APPLICATION No. **15/00966/MJR** APPLICATION DATE: 06/05/2015

LOCATION: WINDSOR BUILDINGS, FERRY ROAD,
GRANGETOWN, CARDIFF, CF11 0JL

PROPOSAL: PROPOSED AFFORDABLE HOUSING DEVELOPMENT
OF UP TO 19 NO. UNITS AND ANCILLARY WORKS

RECOMMENDATION 1 : That planning permission be **REFUSED** for the following reasons :

Drawing Title
Elevations

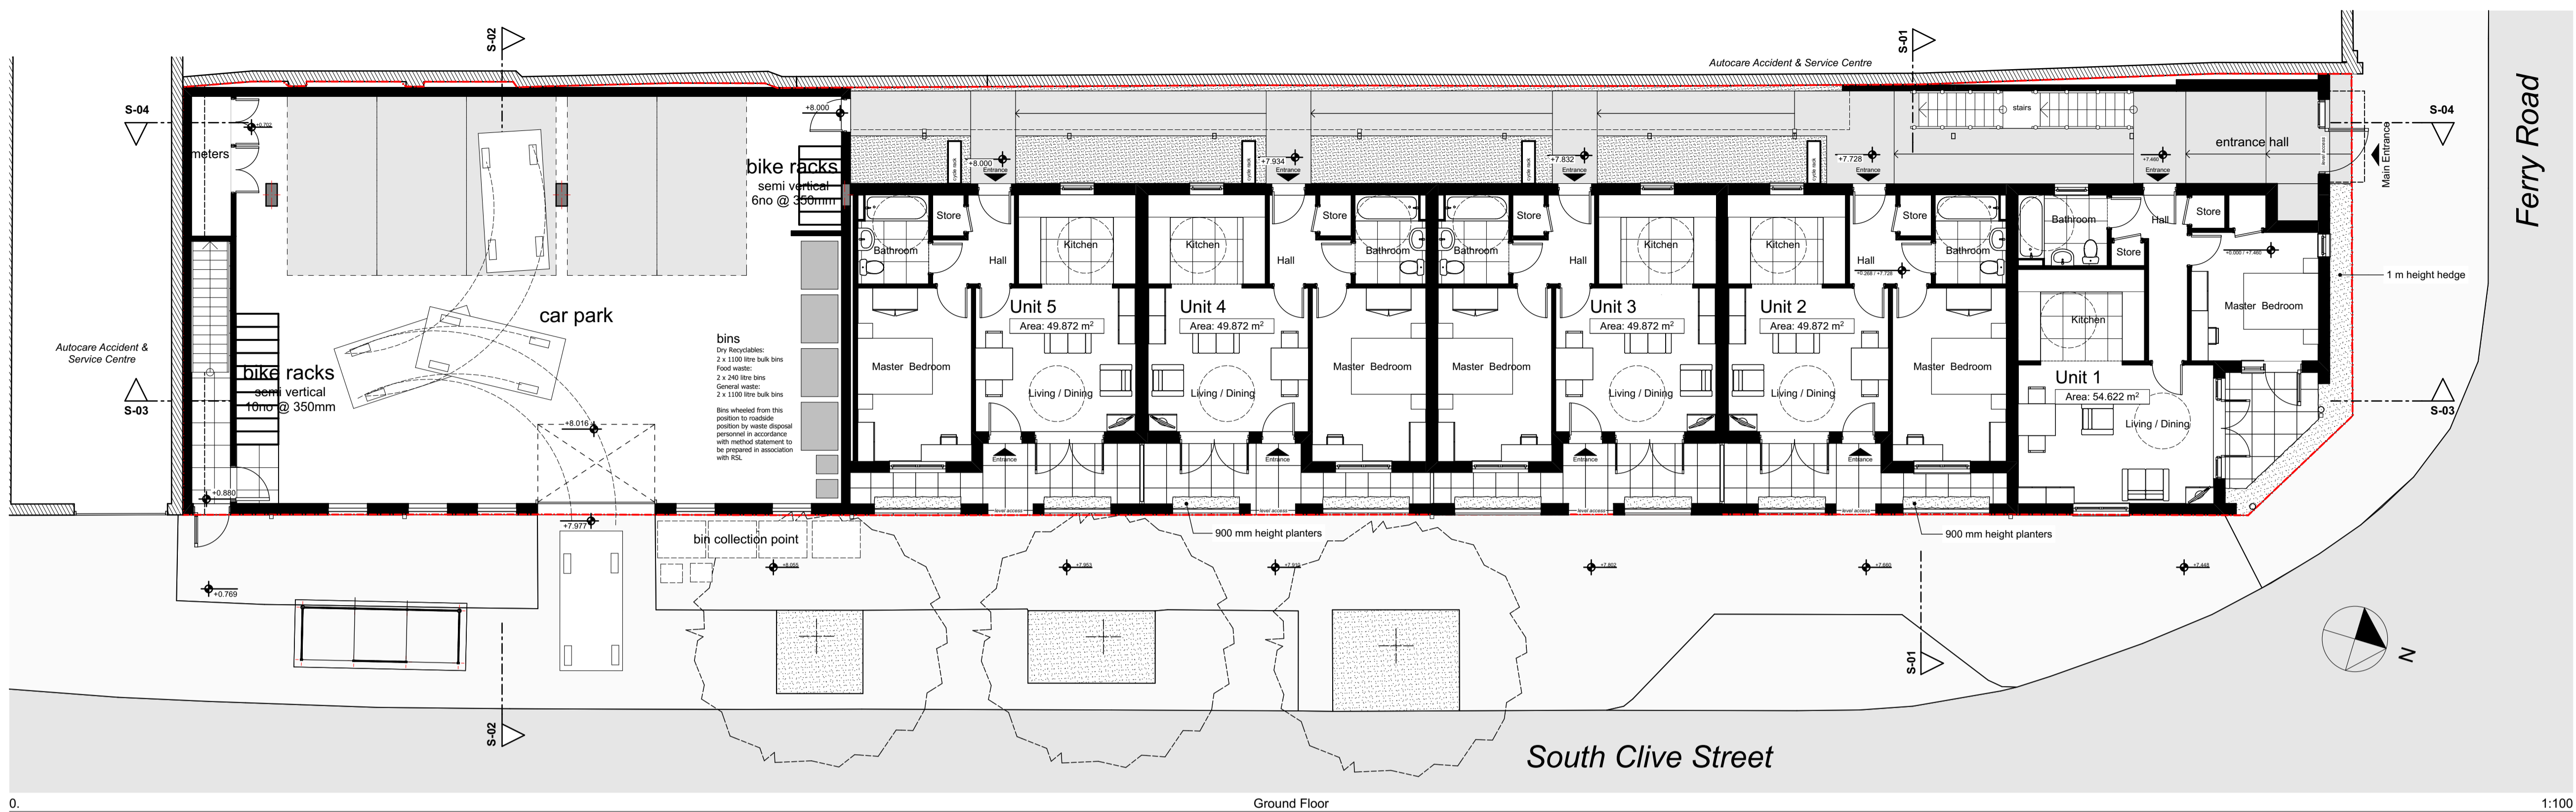
- 8.16 In terms of building presentation, the southern elevation of the building would provide an unfenestrated gable end detail toward No. 2 South Clive Street with a ridge height of 8.5m and a further ridge of 9.5m some 2m further to the north. This roof presentation would be further separated from the immediate neighbour at 2 South Clive Street by an extension to the autocare centre building which returns to the rear of the site and has a monopitch roof of some 5.5m in height and abuts the neighbouring boundary. This allows for a tiering mechanism and a distance of approximately 7.755m between the new flatted development and the side elevation of 2 South Clive Street which is a two storey hipped roof house. This is considered acceptable as a means of grading/breaking up the southern presentation of the development to the height of the immediately neighbouring residence.

- 8.17 The South Eastern corner of the eastern elevation to South Clive Street would present a glazed secondary entrance door to GF level and full height windows at upper levels serving the upper stair core to the southern end of the building; the garage entrance door and associated window openings with roller shutter security further to the north (in a not dissimilar position to the existing warehouse vehicle access), and thereafter a rhythm of 8 columns and infill planter detail enclosures further north again toward ferry road. This would form the enclosure of the GF units which would be set back with a corresponding number of French doors from living room areas of the ground floor units under the balcony overhang of the upper floor flat units. At upper levels the development breaks the façade with a staggered relief, providing for a number of inset balcony presentations with intermittent in-plane bedroom windows. The Ferry Road elevation would also contain balcony features related to the upper floor two bedroomed units.

- 8.19 The Design and Access Statement (Page 12) suggests that whilst the scale of the South Clive Street elevation is higher than the existing, the use of different coloured paints, relief detail within the elevation, and the broken roofline of the building proposed ensures that the impact of this increase in scale mitigated against in terms of visual massing.

- 8.24 The first floor accommodation, being accessed from a walkway similar in character to an American Motel model, or high rise balcony access architecture of the 1960s is also considered compromised by the proximity of the boundary of the autocare repair centre. The section and elevation drawings confirm that the elevation of that building would come to approximately the same height of the balustrade enclosure of the boardwalk access in respect of units 7 to 10 in the mid-section of the building; at a distance of only a metre; and which in respect of the higher level of the garage to the southern end of the site would actually abut and enclose the access deck opposite the western aspect of units 11 and 12. Reducing the amount of daylight to the kitchen and high level bathroom windows of the former units and completely denying any natural light to the kitchen and bathroom windows, of the later. This would similarly be the case for units 6 and 7 at the Northern end of the building. Unit 6 being a replication of ground floor unit 1 with the addition of a further bedroom, and balcony to Ferry Road above the shared access door at ground level.

Drawing Title
Plans

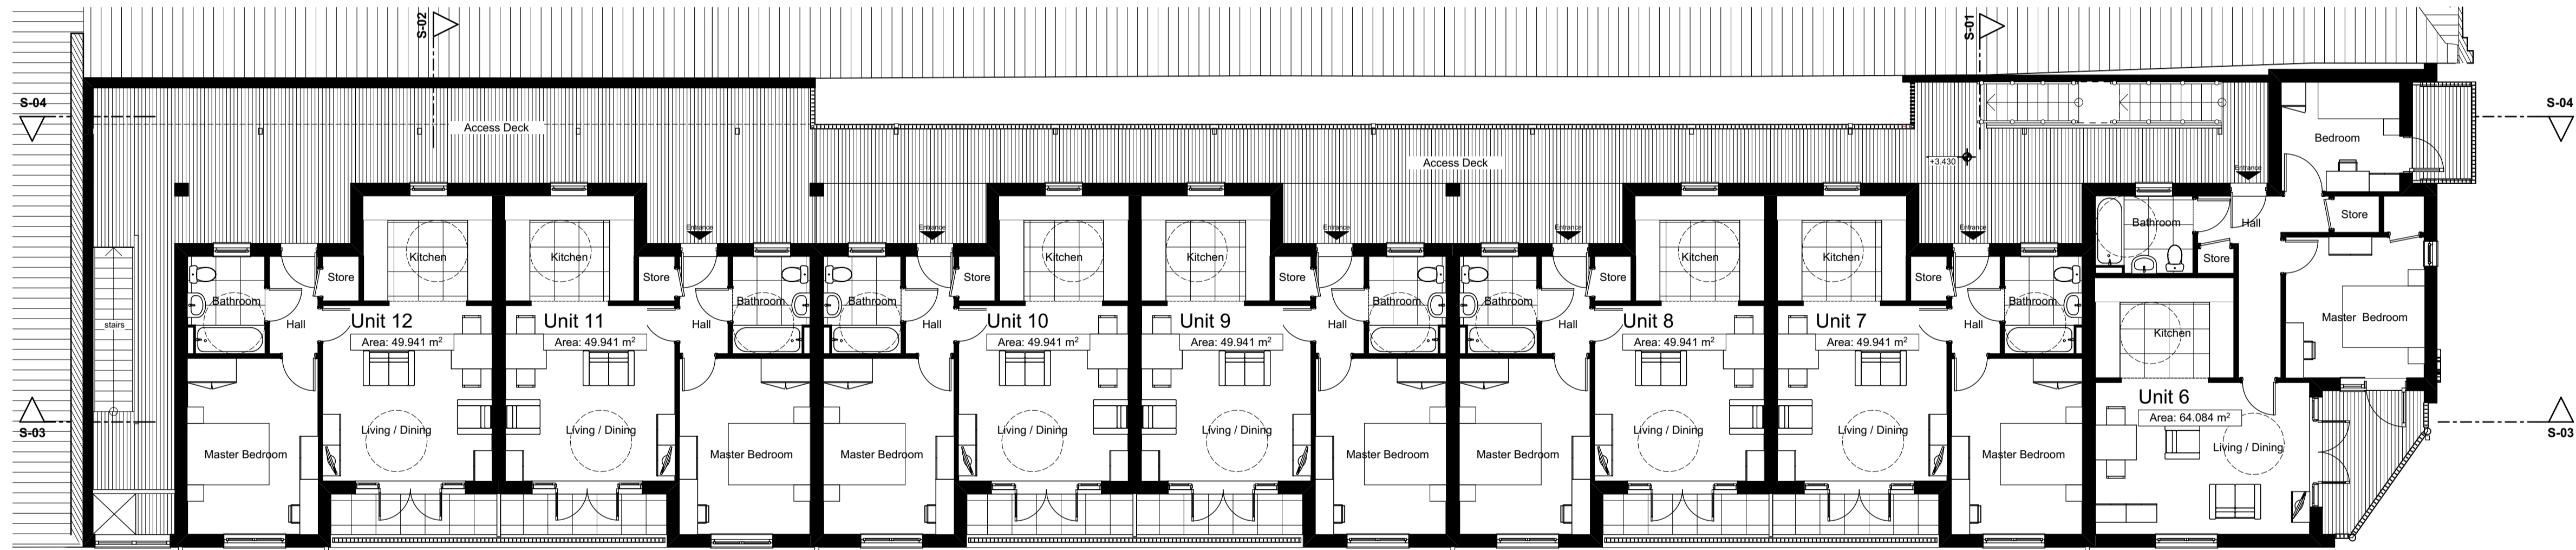
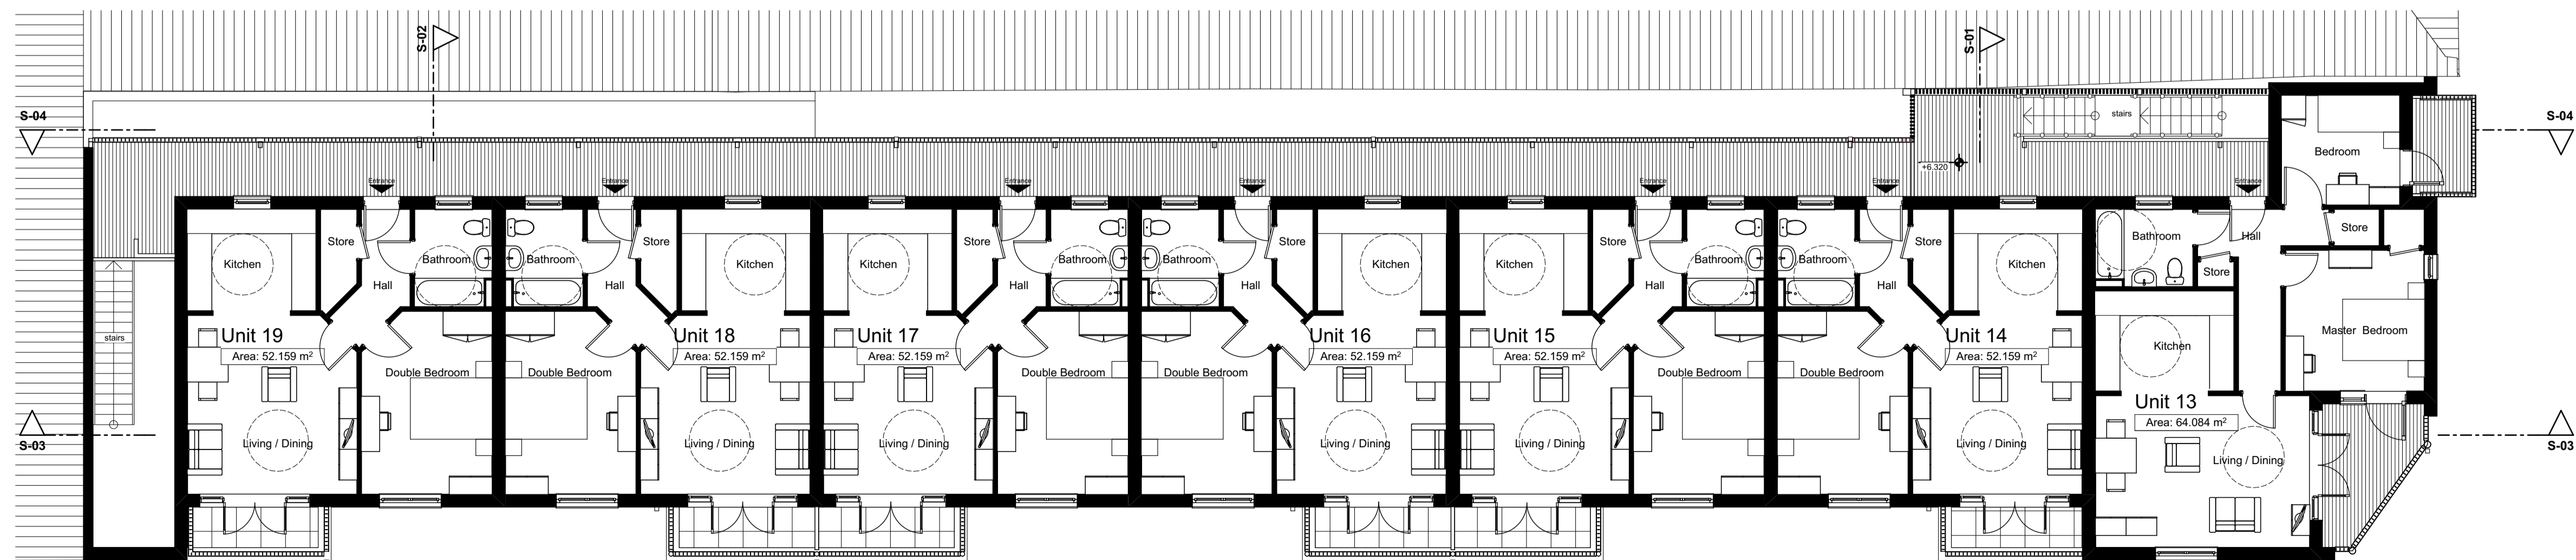
- 8.10 The development proposes whole site coverage on the same near rectangular footprint as the existing building. The accommodation is provided over three storeys with a parking garage for 5 cars, a refuse storage area and five units of accommodation on the ground floor; and seven units of accommodation on first and second floor levels. 17 flats would be one bed roomed and 2 (1st and 2nd floor flats nearest the Ferry Road extreme of the complex) would be two bed roomed. [19 units – 21 beds total].

- 8.14 Access to individual flats utilises a communal deck access to the west of the building adjacent to the autocare centre boundary on all three levels. This realises an integral corridor access at ground floor; an semi-enclosed balcony terrace at first floor which becomes enclosed at both ends by virtue of the staircase enclosure and higher level wall of the repair garage buildings to the southern end of the site; and an open balcony to second floor levels, with the two upper levels fronting the roofscape of the adjacent repair garage.
- 8.15 This design concept is not favoured, as it necessitates having to go outside the building to access individual flats on the upper two levels.

- 8.23 At ground floor, the principal access to the apartments is considered to be very oppressive, formed by an wall set back only a short distance from the corresponding boundary wall of the repair garage, the access is essentially an internal corridor, and speculated by the planning officer, especially in respect of the units with an alternative access onto South Clive Street, unlikely to be used. The rear outlook from kitchen windows on the ground floor would therefore be into an internalised space with no natural daylight, and no natural bathroom ventilation in respect of units 2 to 5. Unit 1 would have a high level bathroom window, but into this enclosed and shared communal internal area which is considered unsatisfactory. The alternative outlook from the Ground floor apartments, being the outlook from the principal living rooms and bedrooms of units 2-4 onto south Clive street would in the opinion of the planning officer, be adversely affected by the overhanging balcony arrangement of the upper level accommodation, resulting in a very dark and oppressive access and outlook to both sides of the accommodation. The planter enclosures to South Clive Street also giving a less than desirable enclosure in terms of site security and defensible space in comparison with the defensible front gardens of adjacent properties. Unit 1, being the GF flat to the Northern end of the site abutting the Ferry Road footway would have a living room window directly to the back of the South Clive Street footway, a recessed patio with Living room French doors and a glazed bedroom door and lite, set back behind a 1m high hedge boundary to the cropped Ferry Road Corner of the building and a further small bedroom window to the back of the Ferry Road footway on its northern elevation. All of which are considered unsatisfactory in respect of outlook and

- 8.25 As indicated previously this arrangement requires residents of flats 8, 9 and 10 having gained access to the interior of the building, to have to go outside the building again to access their apartment entrance doors.

8.45 The undercroft garage and servicing area would appear to have sufficient space for bin storage and the adjacent highway to be wide enough for presentation of bins on collection days
